Subject: Submission to DA/2019/1309 257 Whale Beach Road

Re Submission to Development Application DA/2019/0309 for the demolition of the existing dwelling and construction of a new dwelling house at 257 Whale Beach Road, Whale Beach

2. PHOTOGRAPHIC REVIEW

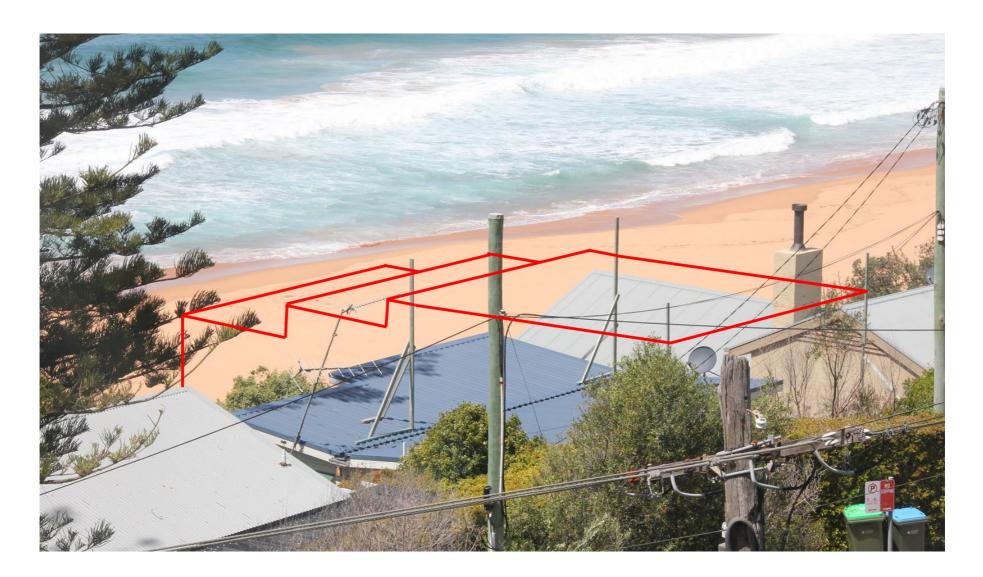
The following provides a visual indication of the expected loss of views which will result from the proposal taken from the primary living area at 232 Whale Beach Road. As indicated, this property's of a 'full view' of the sand and water interface will be obstructed. This has been interpolated from the height poles erected on the site. We have been advised that the height poles have been erected for some time and therefore we have made the assumption that they represent the height of part of the proposed development prior to the consent. Our representation of the envelope have been adjusted accordingly.

The photograph was taken from a standing position on the outdoor private open space off the living room at No 232. The impact from a sitting position or the terrace or in the living room would be greater. Views from other levels of No 232 would be impacted also. **See image overleaf.**

View impacts from Nos 228 and 230 Whale Beach Road would also be affected in a similar manner to varying degrees.
